MILITARY SPECIFICATION

MODULES, STANDARD ELECTRONIC

MEMORY, RANDOM ACCESS, DIGITAL, KEY CODE KYF

This amendment forms a part of Military Specification MIL-M-28787/286(EC), dated 14 June 1979, and is approved for use by the Naval Electronic Systems Command, Department of the Navy, and is available for use by all Departments and Agencies of the Department of Defense.

FIGURE 16. Input clamp diode voltage test circuit for table VIII.

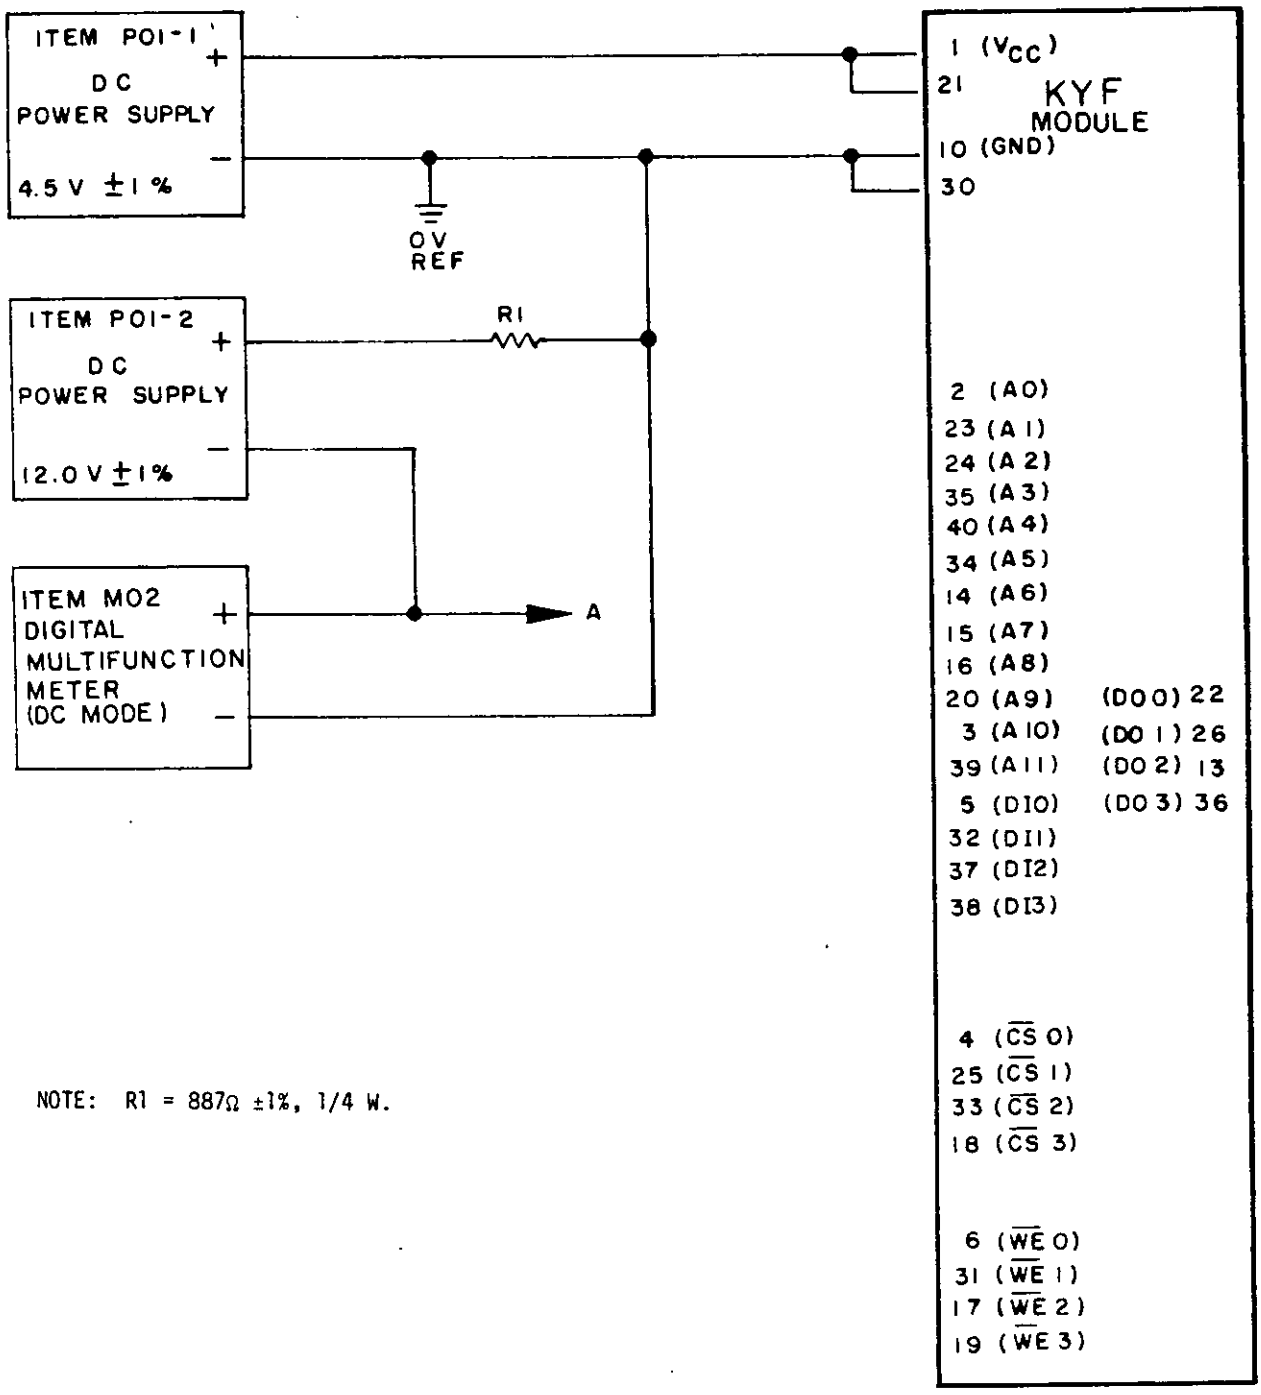
FIGURE 16: Delete and substitute new figure 16 as printed on page 4 of this amendment.

NOTE: R1 = 887Ω ±1%, 1/4 W.

FIGURE 17. Static output voltage (low-level and high-level) test circuit for table IX.

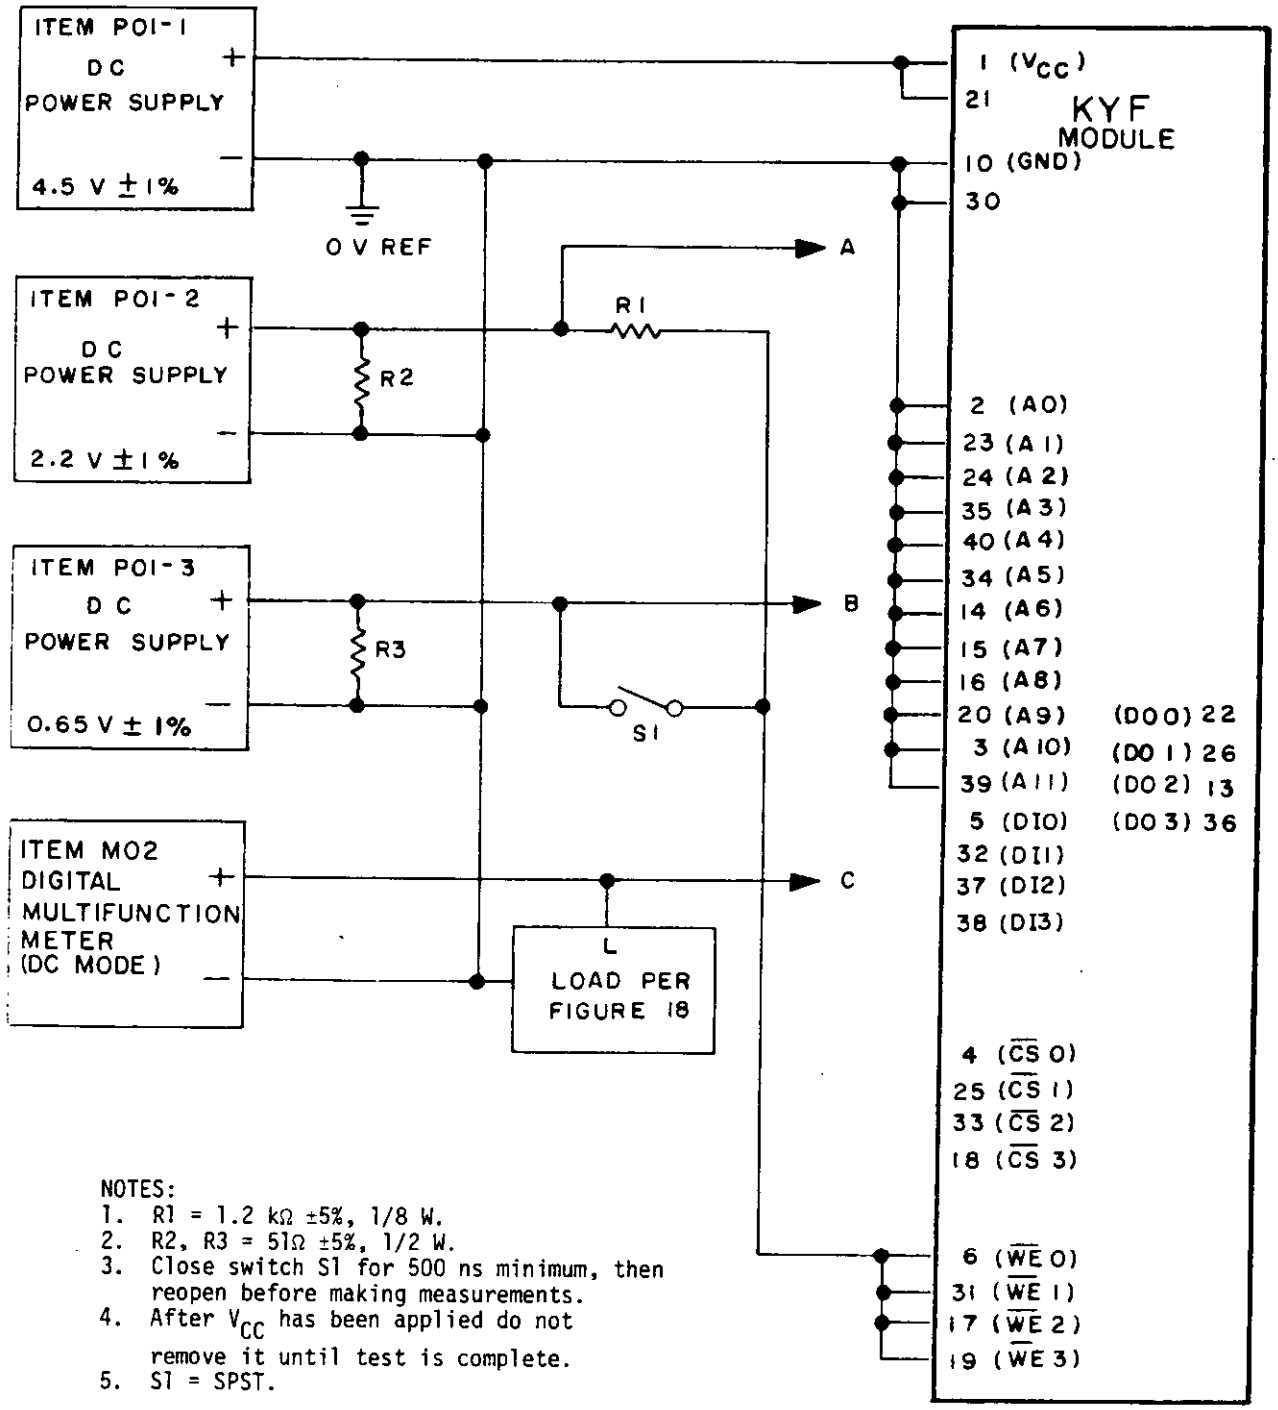
FIGURE 17: Delete and substitute new figure 17 as printed on page 5 of this amendment.

NOTES:
1. R1 = 1.2 kΩ ±5%, 1/8 W.
2. R2, R3 = 51Ω ±5%, 1/2 W.
3. Close switch S1 for 500 ns minimum, then reopen before making measurements.
4. After V_{CC} has been applied do not remove it until test is complete.
5. S1 = SPST.

FIGURE 21. Address input threshold check (low-level and high-level) test circuit for table XII.

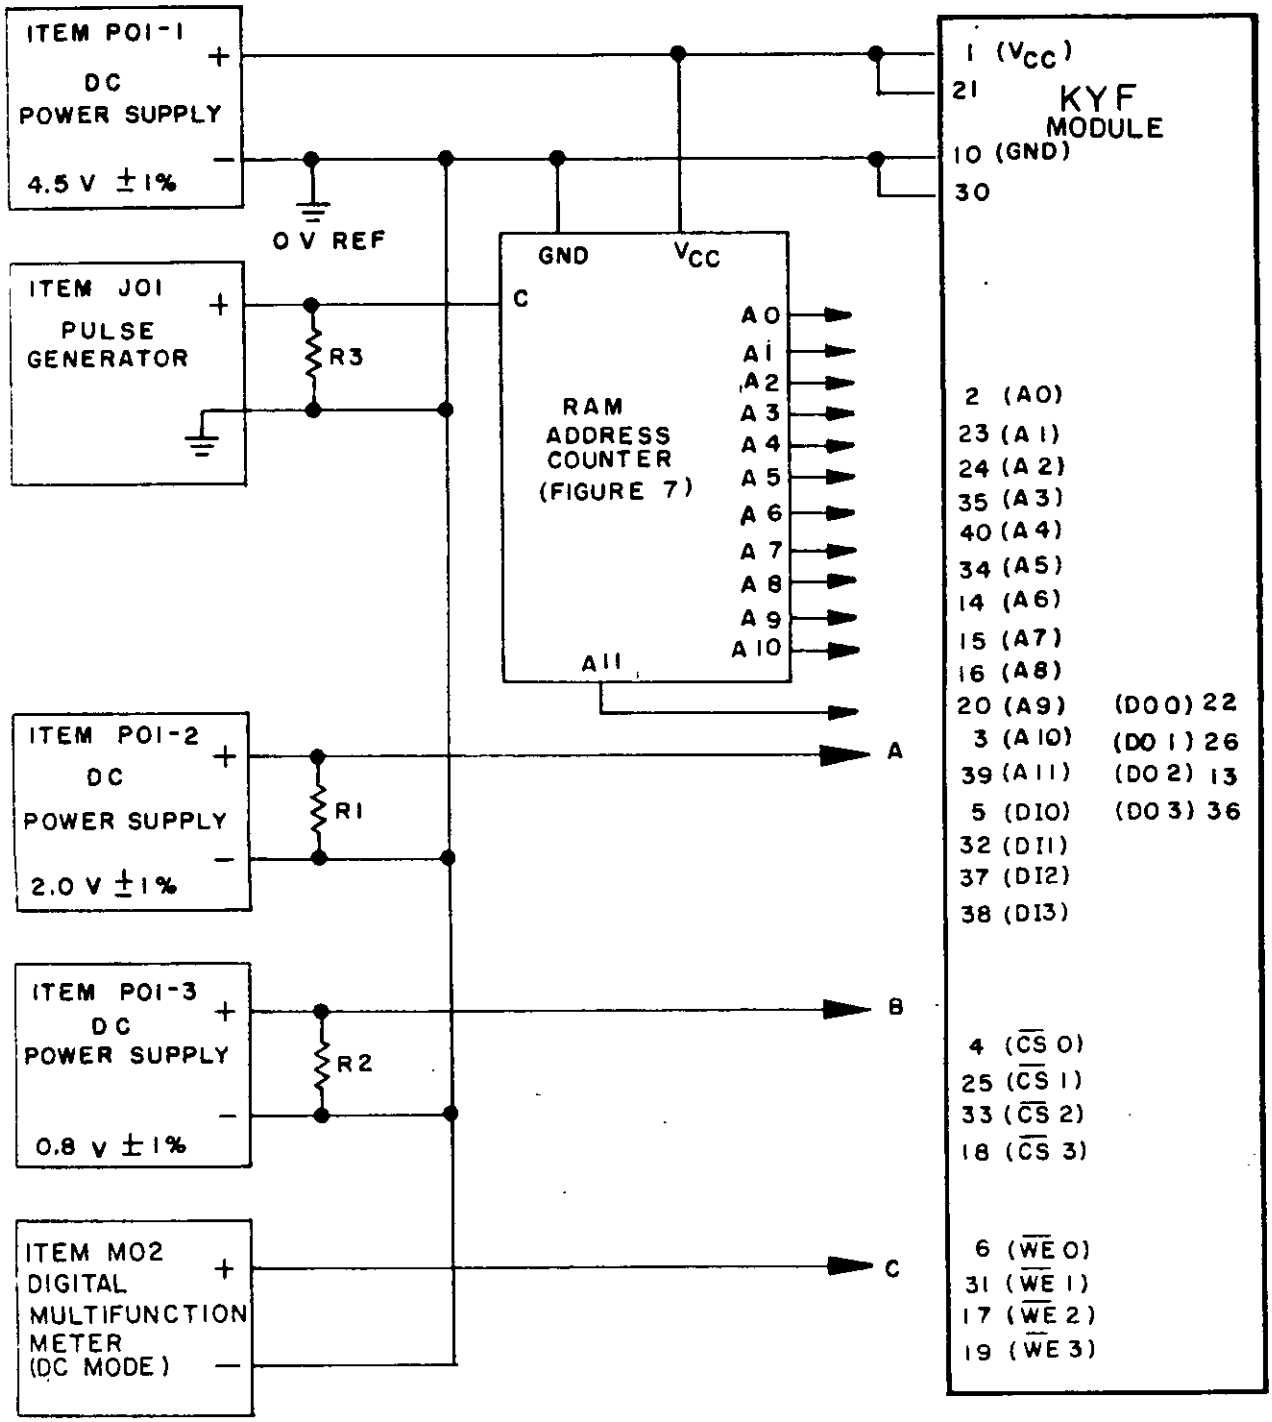
FIGURE 21: Delete and substitute new figure 21 as printed on page 6 of this amendment. (Notes for figure 21 printed on page 49 are not to be deleted).

FIGURE 28. Dynamic test circuit for table XVII.

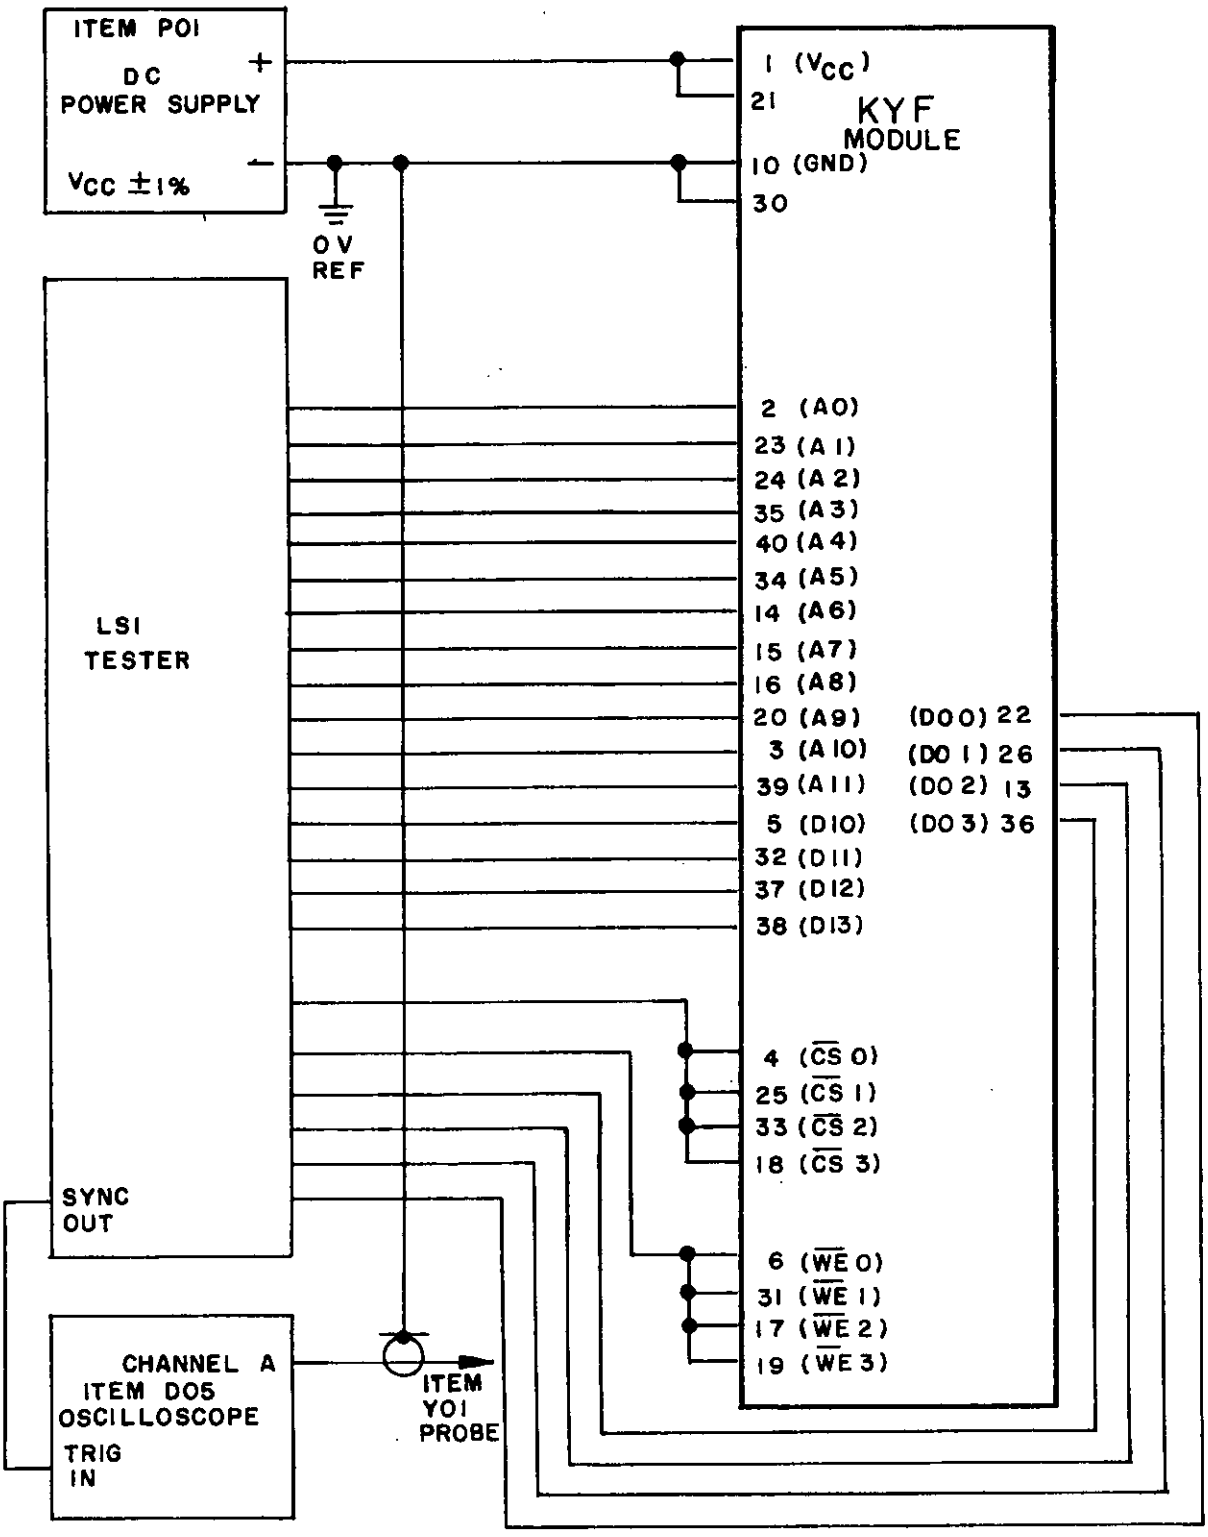
* FIGURE 28: Delete and substitute new figure 28 as printed on page 8 of this amendment.

NOTES:
1. V_{CC} = 4.5 V ±1% for test conditions S1, S3, S5, S7, S9 and S11.
2. V_{CC} = 5.5 V ±1% for test conditions S2, S4, S6, S8, S10 and S12.
3. Load output pins 13, 22, 26 and 36 with load as specified on figure 18 with C_L = 50 pF for test conditions S1-S6.
4. Load output pins 13, 22, 26 and 36 with load as specified on figure 18 with C_L = 150 pF for test conditions S7-S12.
